Subject: FW: N of Summer Lane P/35/20/DOC & P/37/20/DOC

We have the following comments regarding the revised surface water drainage details submitted for P/35/20/DOC and P/37/DOC.

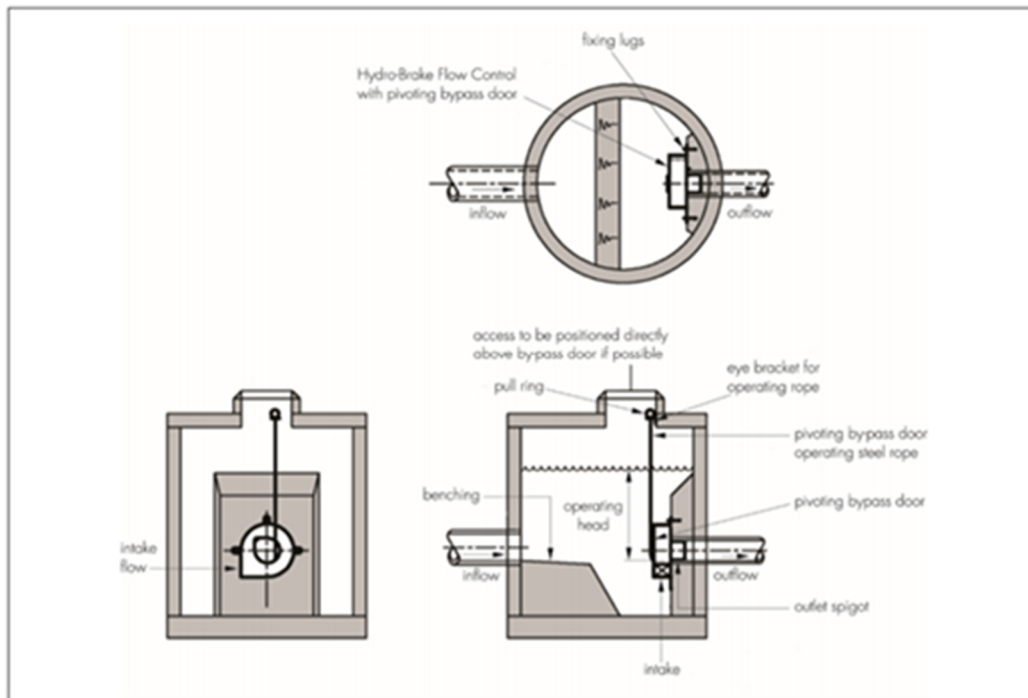
9. All headwall grilles to be cranked as opposed to be flat or just sloped faced. Headwalls SW-4, SW-5, SW-9, SW-13, SW-29 and SW-32 updated to cranked grilles. *Headwall SW-9 cross-section grille not shown (layer not visible?), please ensure this is visible on drawings. Please remove note to Sewers for Adoption, please add construction detail showing typical grille, ensuring that bar spacing, materials, point of lock are shown.*
